Subject: UniStar Nuclear Docket No. 52-016
Submittal of the Published UniStar Nuclear Topical Report No.
UN-TR-06-001-A, "Quality Assurance Program Description," Revision 1

**Proposed Revision 1 of Topical Report UN-TR-06-001
incorporating responses to RAIs (and other changes) as indicated by bars in the
margin**

**QUALITY ASSURANCE
PROGRAM DESCRIPTION**

Figure A-1

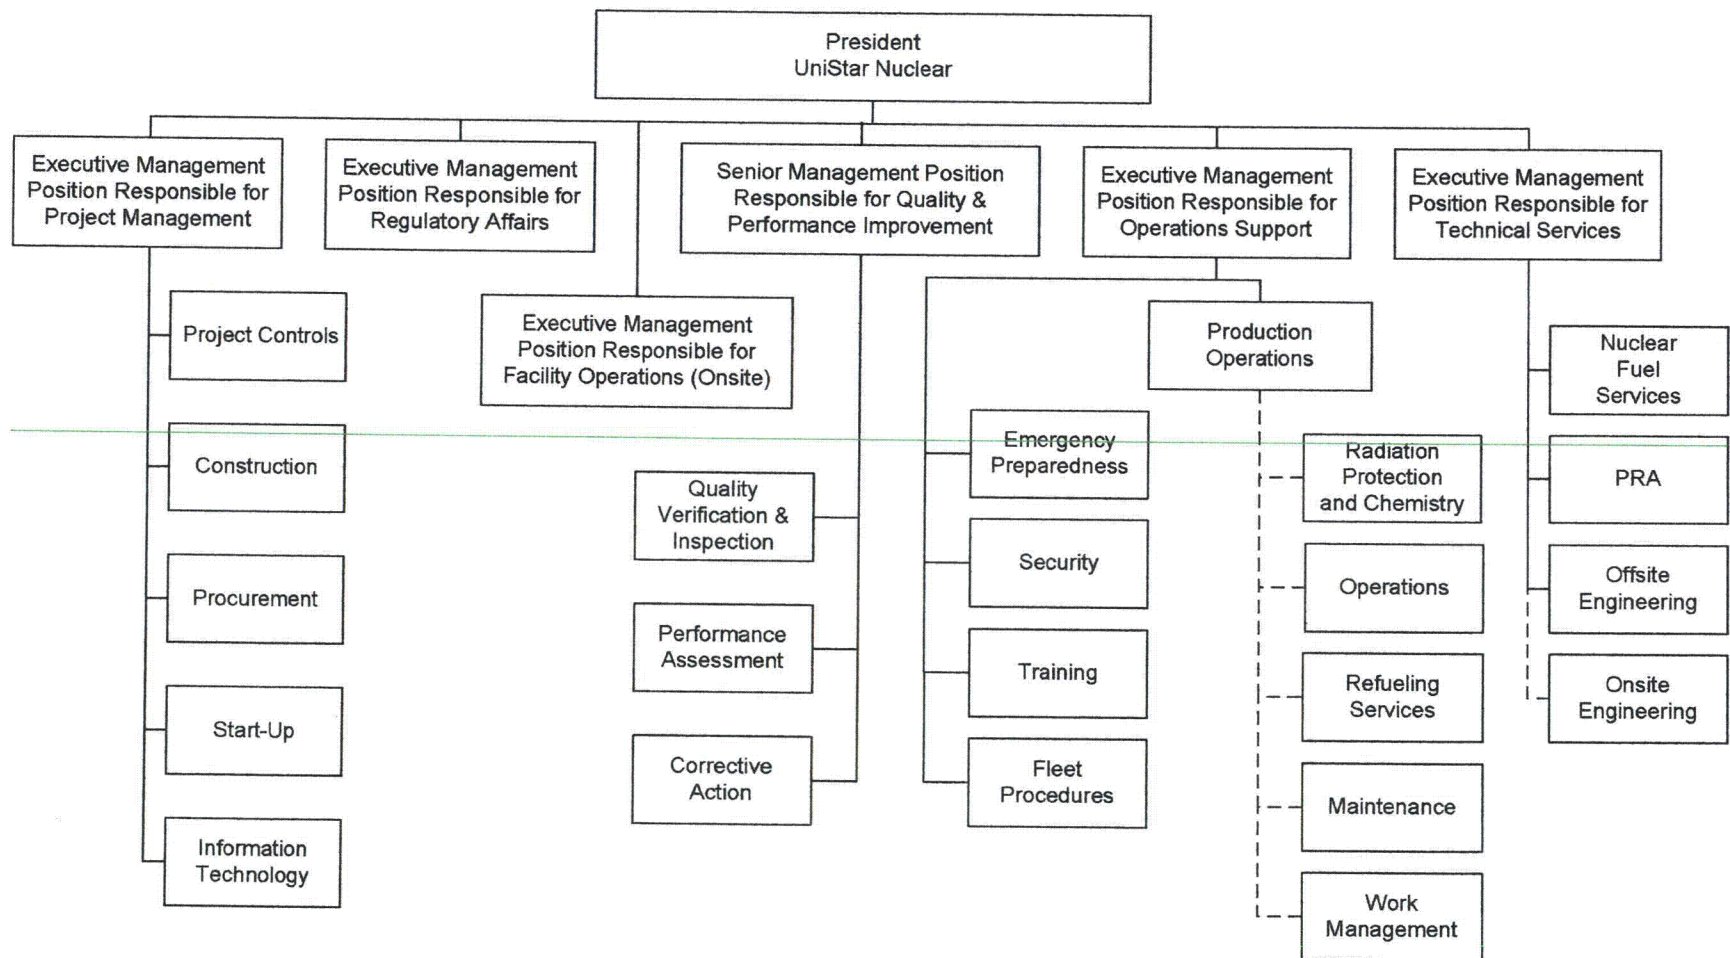
1) Position titles in Section A and elsewhere were revised to reflect the titles and shifts in existing responsibilities to the positions.
